**RE: Proposed Central Coast Regional Cancer Centre
Gosford Hospital Cnr Holden Street and Racecourse Road GOSFORD NSW
2250
Part 3A Major Project MP10_0173
Assessment of Accessibility for People with Disabilities**

The following drawings were reviewed: DOP06 (02), DOP 06 (02), prepared by Silver Thomas Hanley Health Architecture to confirm access for people with disabilities to be provided throughout the site.

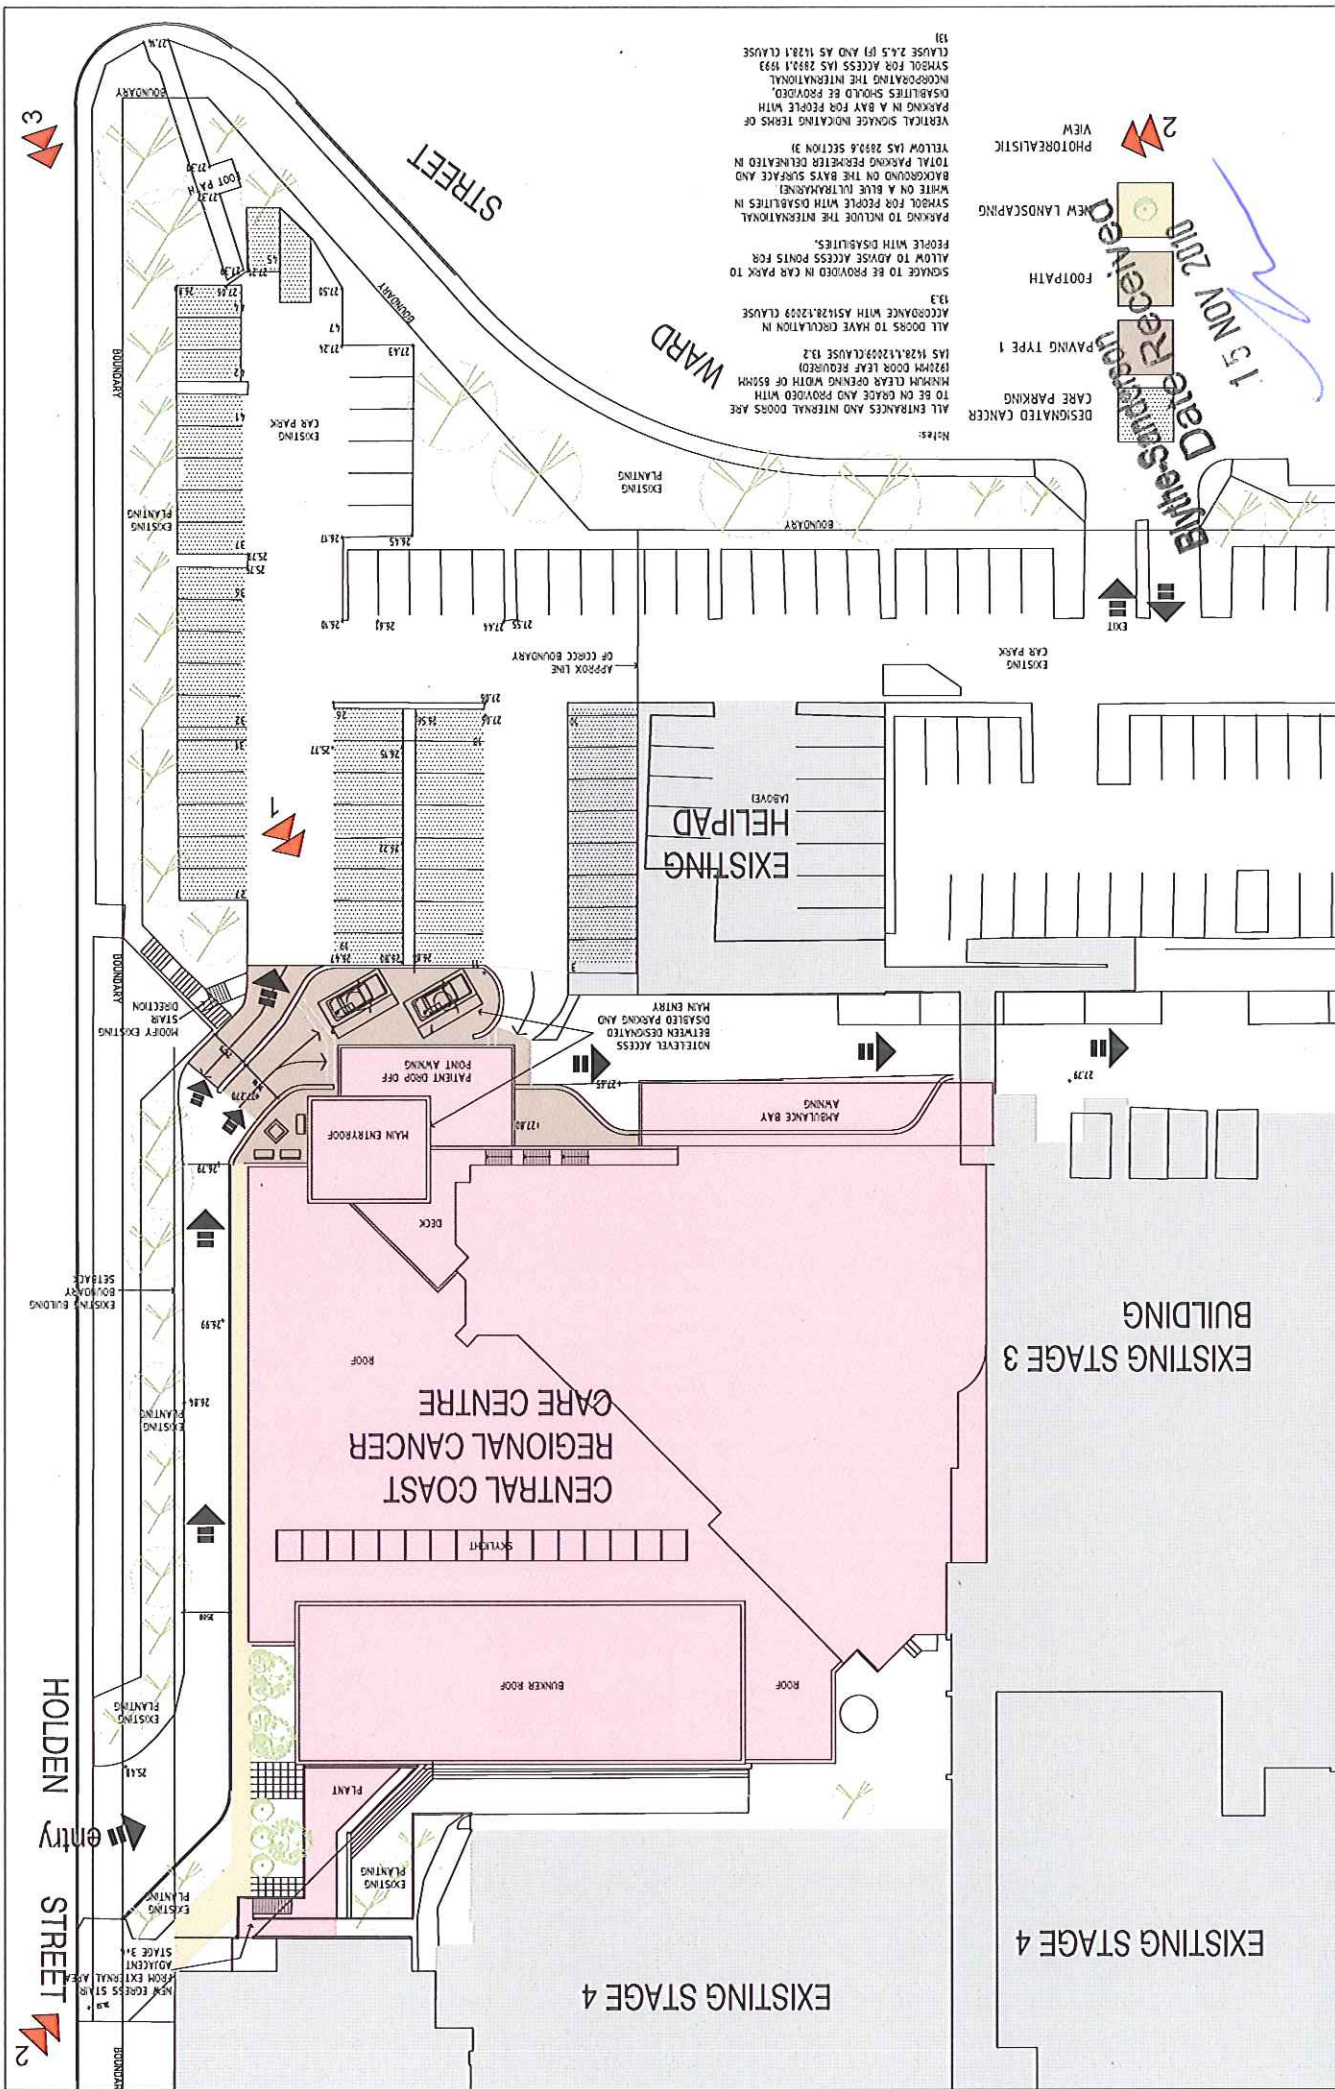
A total number of 46 additional car parking spaces are provided to the site, with two designated parking bays for people with disabilities provided centrally to the main entrance. The spaces have appropriate dimensions of 3200mm x 5400mm as per the relevant Australian Standard.

A continuous accessible path of travel with minimum width of 1800mm is provided from Cancer Centre Entry.

A continuous accessible path of travel, with minimum width of 1500mm is proposed from the allotment boundary (Holden and Ward Street) and accessible parking bays to the main entrance. Passing areas are generally provided to enable two wheelchair users to pass with a couple of areas as stated previously.

The gradient of the proposed pathways are appropriate. All walkways shall not have a gradient exceeding 1:20. This is noted on the drawings.

DRG NO: **DoP 07**
 REVISION: **02**

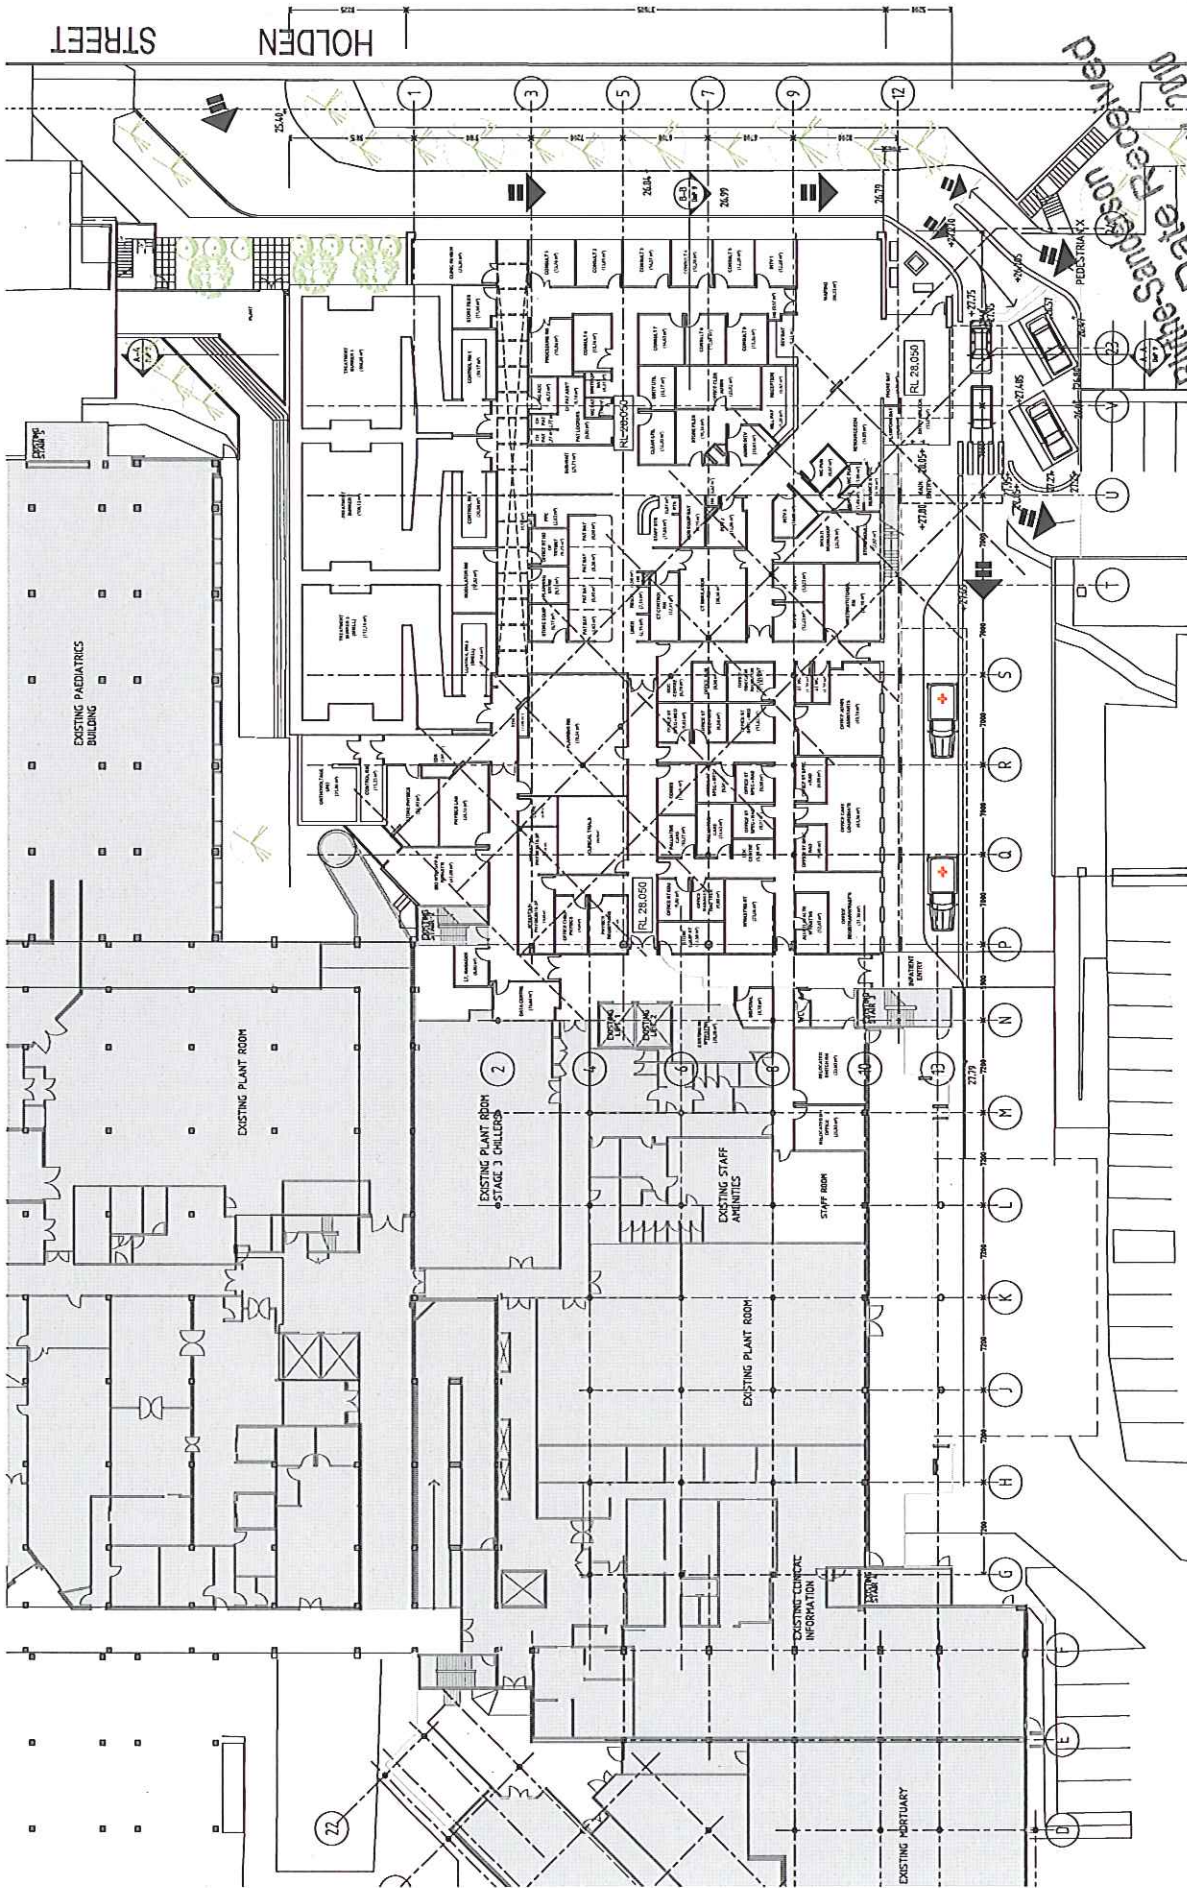
The main entrance to the centre consists of an automatic door which provides appropriate clear opening width of 850mm for people with disabilities. The approach to the entrance will be at 1:40 grade that provides a clear, level landing area on both sides of the door for wheelchair maneuvering and for ambulant people using mobility aid.

The proposed internal doors will achieve a clear opening of no less than 850mm wide (920mm door leaf) and are provided with appropriate circulation space for their operation with the exception of. This is noted on the drawings.

There is one unisex accessible sanitary facility for people with disabilities provided for staff and visitor use. The facility is located adjacent to the gender facilities adjacent to the reception. The internal dimensions of this facility are appropriate at 2100mm x 2700mm. The fixture placement will ensure clear circulation of 1900mm X 2300mm to the pan. The washbasin will not encroach more than 100mm into this space.

Ambulant sanitary facilities are proposed within the two gender facilities. The ambulant facilities are located within the gender toilet facilities and have appropriate circulation space in front of the pan (900mm) and to the door of the cubicle.
